TSB No.	KFE10-21-V070-ED	TSB Type	Field Fix	Language	English
Distributor	C41VD(LOCAL)	Published	5/28/2010	Modified	
Model	Cee'd [ED]-(2007MY)				
Area & Distributor	East Europe & Falcon Auto				
Gr./Sys./Comp	Система подвески / Система передней подвески / Передний стержень стабилизатора				
Subject	(REVISED) FRONT STABILIZER LINK ASSEMBLY INSPECTION AND REPLACEMENT				
Description

**REVISION NOTICE****THIS BULLETIN SUPERSEDES PREVIOUS TSB KGE09-21-V160-ED. DISCARD THE PREVIOUS TSB.**

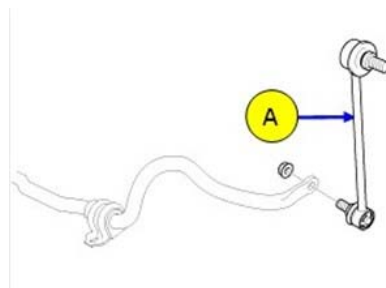
- 1) Replace the wheel speed sensor assembly according to the applicable workshop manual.

*While replacing the front stabilizer link assembly unit (A,) be sure to use correct tightening torque for the nut while assembly.*

- Tightening torque Nm (kgf.m, lb-ft):  
100~120 (10.0 ~12.0, 72~87)
